Subject: LaSalle County Nuclear Power Station Units 1 and 2
ComEd Response to NRC Staff Request for Additional Information (RAI)
Regarding Modifying the Main Steamline Tunnel Automatic Isolations
NRC Docket Nos. 50-373 and 50-374

Response to the RAI on MST T and ΔT

Figure 6: Upper MST VR Delta T due to Steam Leakage in Lower MST

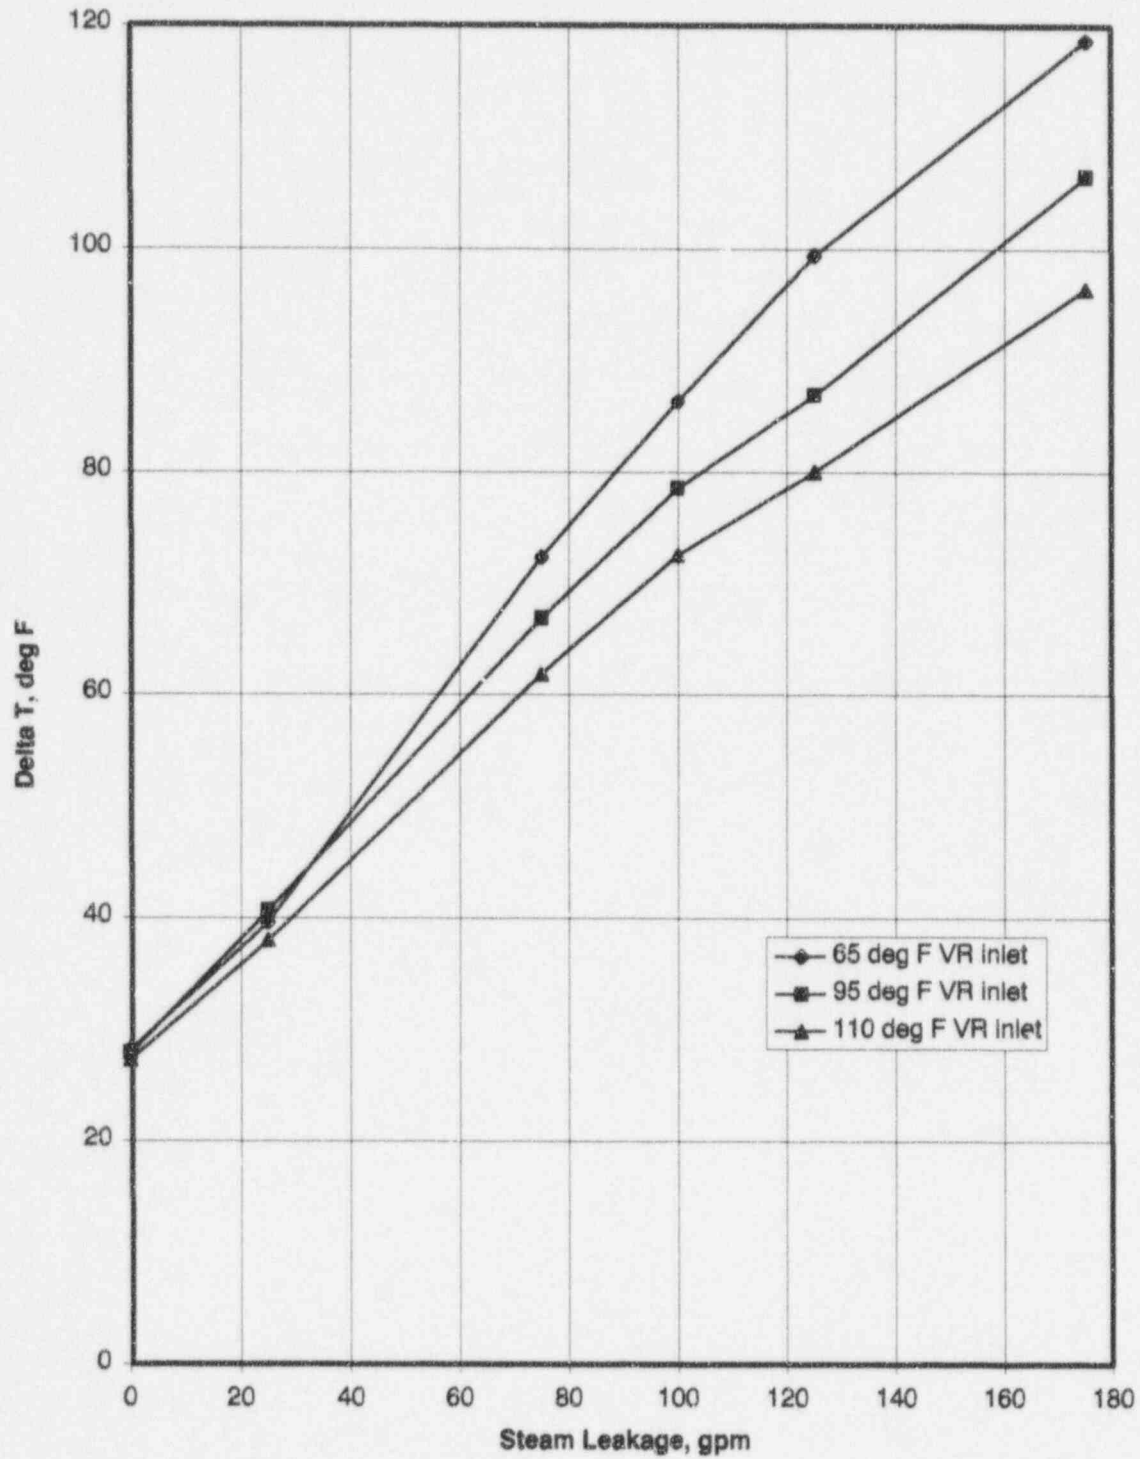
Provide a summary of the GOTHIC calculations, including the results for normal operating conditions in the main steamline tunnel (MST) which verify the analytical methods used to determine the differential temperature high-setpoint. Specifically, provide the conditions and the analytical assumptions shown on page G-3 of your submittal dated January 18, 1996.

Figure 6 shows the temperature difference between the upper MST exhaust and inlet air (MST Delta T). These are the Delta T's at approximately 10 minutes after the leak. In most cases, the Delta T has reached a steady state value, and if it has not, it is very close to the steady state value. The results show that the Delta T varies directly with the quantity of steam leakage. For a given leakage rate, the upper MST Delta T is highest for a MST inlet temperature of 65°F and lowest for a MST inlet temperature of 110°F. The upper MST delta-T's at 10 minutes for a 100 gpm leak are 86.3, 78.5 and 72.5°F respectively for MST inlet temperatures of 65, 95 and 110°F. Corresponding to these MST inlet temperatures, the delta-T's for no leak condition are 28.2, 27.9 and 27.3°F. If one setpoint value is used to cover the whole range of expected MST inlet temperature conditions, then the lowest calculated delta-T for 100 gpm leak (72.5°F) must be greater than the highest calculated delta-T for no leak (28.2°F). This difference of 44.3 degrees is sufficient to cover the margins and uncertainties associated with the setpoint determination methodology. The calculated delta-T value of 72.5°F is also greater than the delta-T experienced in the MST when the VR system is out of service. The delta-T has been observed as high as 46°F. Therefore, a delta-T setpoint based on 100 gpm leak will not cause spurious trips when no leak is present or when VR system is out of service.
